Ref: BHE/PW/PUR/TLRPT- CHIMNEY/2660 /Corg-02

Sub: Corrigendum-02: Clarification

JOB Description : Construction of One (1) no. 275 m tall twin flue RCC chimney (Civil, Structural, Mechanical and Electrical) excluding supply & application of borosilicate glass block lining system at 2X660MW NTPC TALCHER TPS PROJECT, Odisha.

TITLE: WORKERS ACCOMODATION
FLOOR PLAN & ELEVATIONS

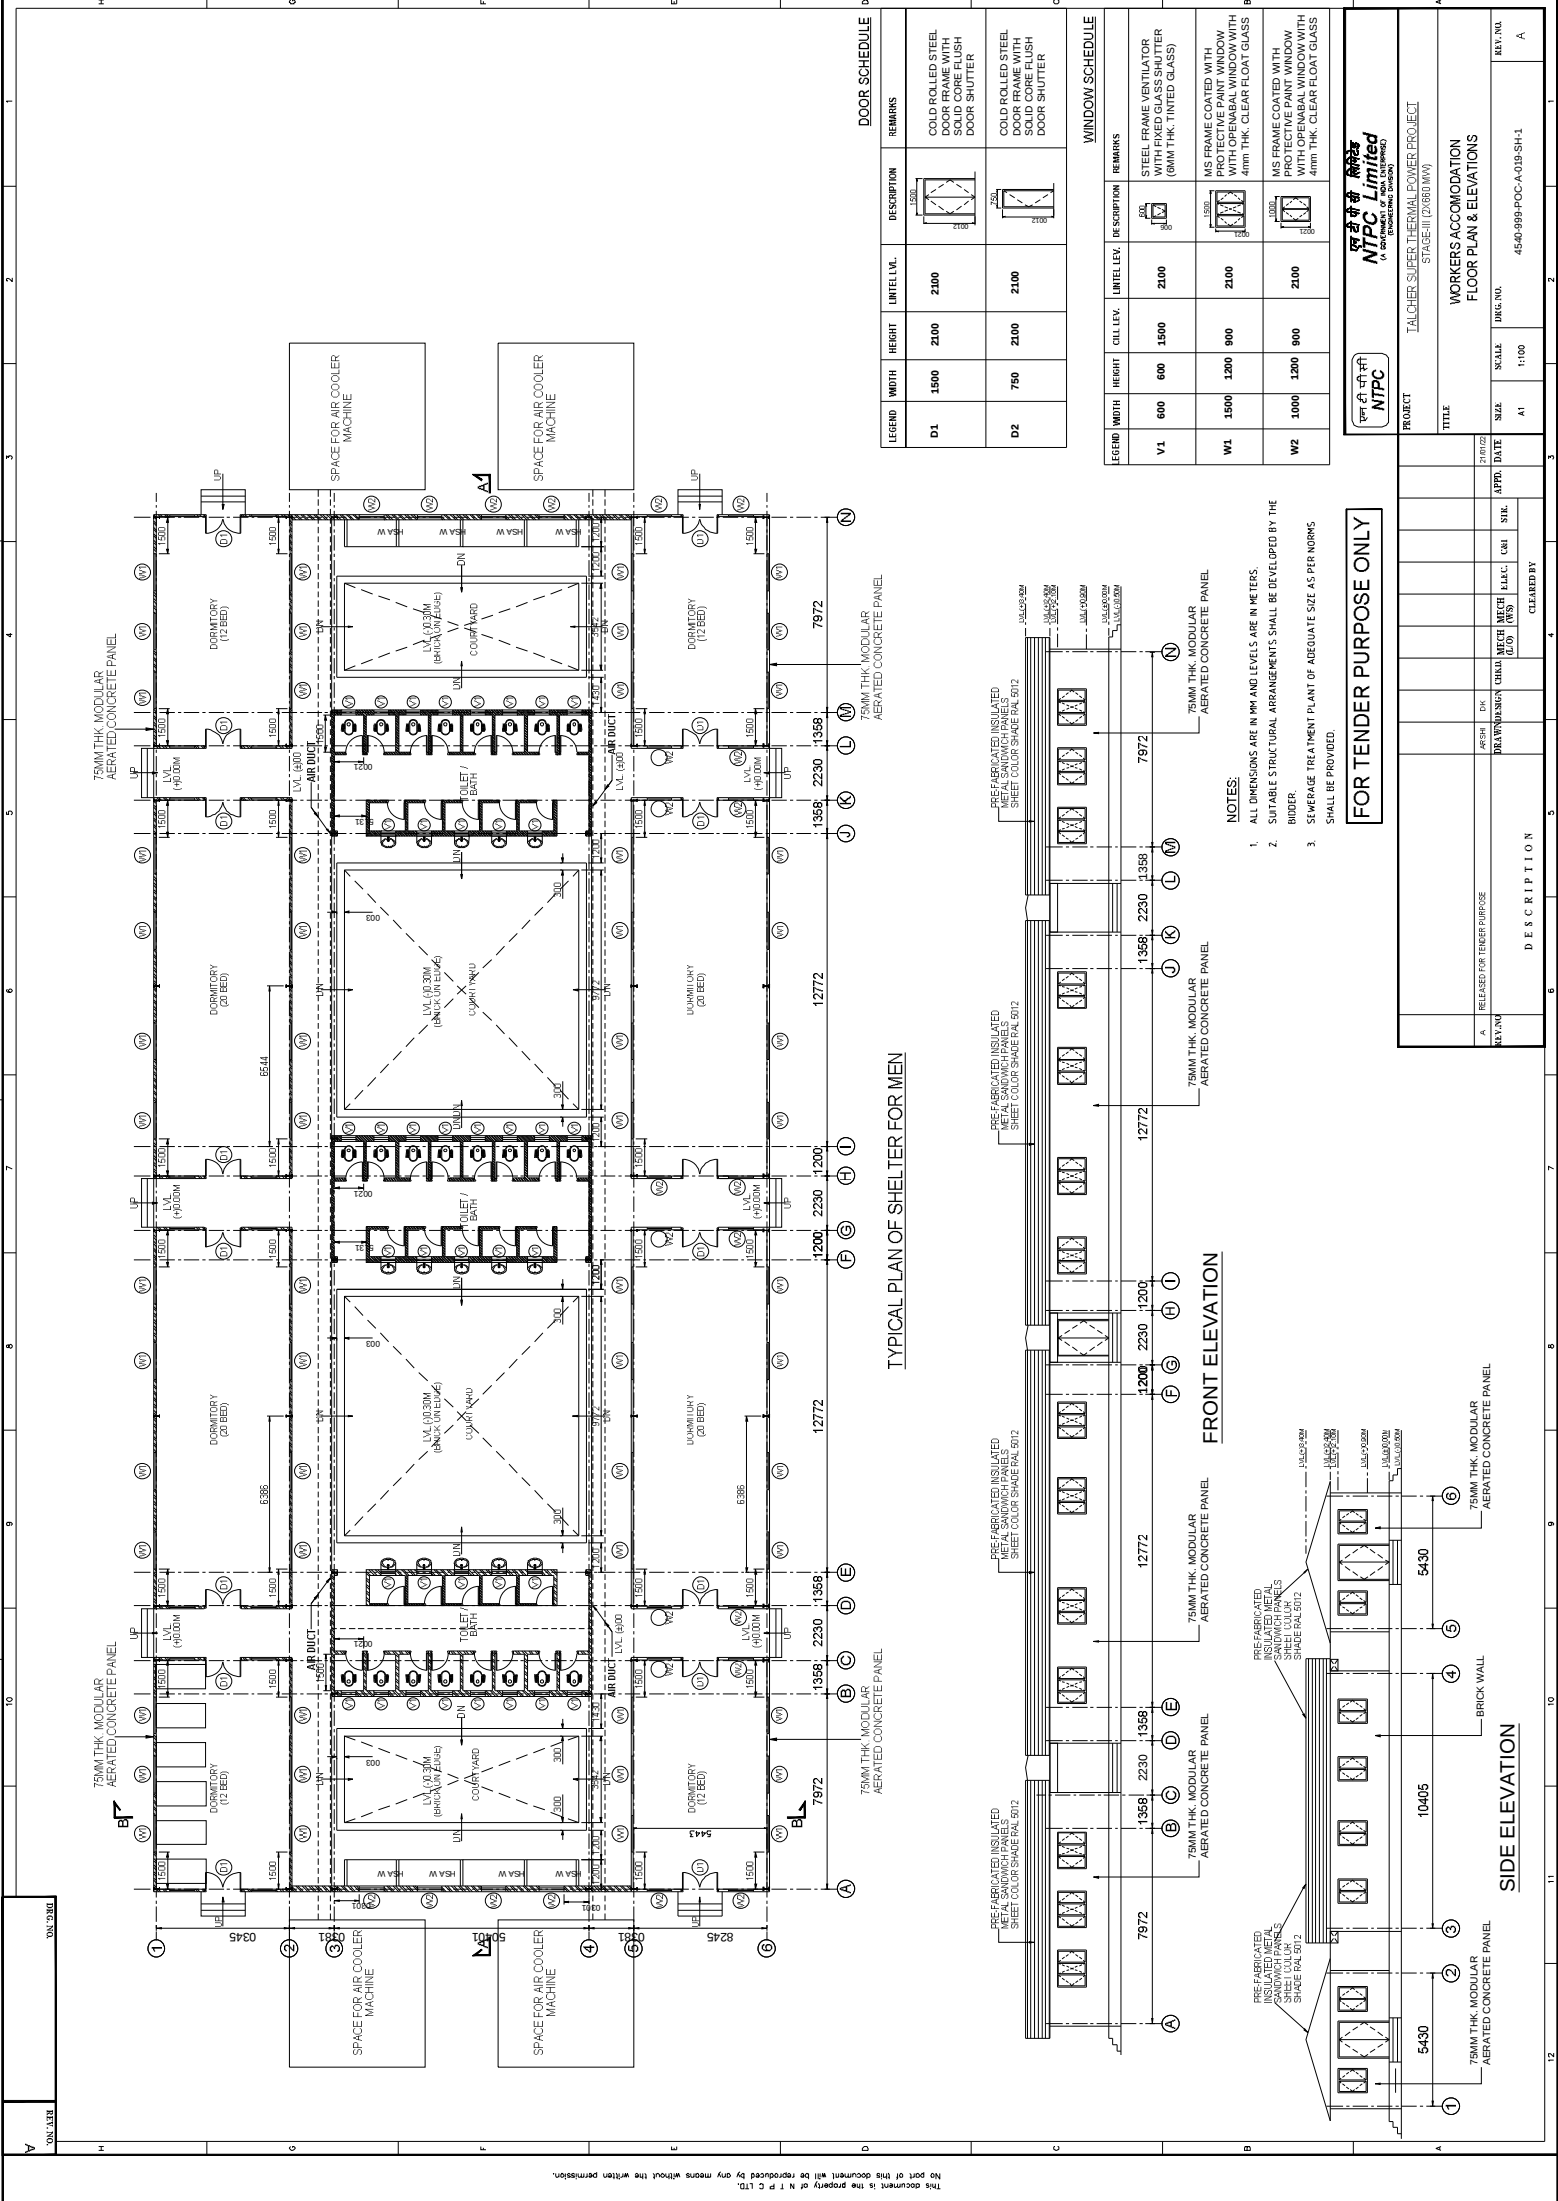
Sl. No.	Reference clause of Tender Document	Existing provision	Bidder's query	BHEL's Clarification
4.	Clause No. 2.2.18 TECHNICAL CONDITIONS OF CONTRACT	Development of Bidders temporary staff colony and labour colony having adequate no. of rest rooms along with toilets & fencing etc. (enclosing drawing for ready reference).	Please send us the drawing of staff and labour colony for our reference.	Workers Accommodation Floor plan and Elevations (Drawing copy Enclosed)

Enclosure: Drawing of Workers Accommodation Floor plan and Elevations
